SERVICE LETTER / NOTIFICATION – FEB 13, 2023

Upgrade your rudder pedals 7C4-1J

CH 701 STOL

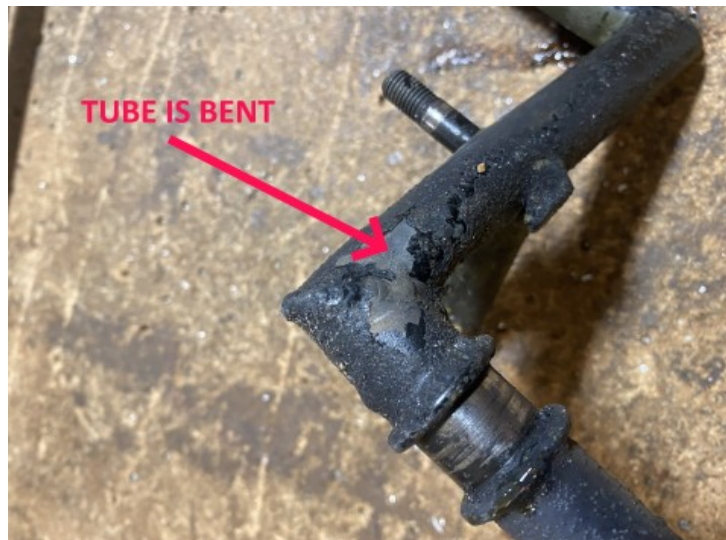
A 701 customer noticed the rudder pedals 7C4-1J had a bend in the bottom corner. After removing the pedals he noticed the wall thickness on the tubing was 0.035” instead of 0.058”.

The original 701 rudder pedals 7C4-1J were welded together with a 0.035” 4130N type tubes. This was later changed to a 0.058” 4130N type tube, to be consistent with the other CH designs.

Inspect your rudder pedals. Check the tube thickness.

The bottom tube in the photo is thicker at 0.058”. This is the correct tube type. Pedals with thinner tube must to be changed to avoid bending or possible cracking.

If your rudder pedals were manufactured with the 0.035” tube thickness, you need to upgrade your pedals to the 0.058” tube thickness.
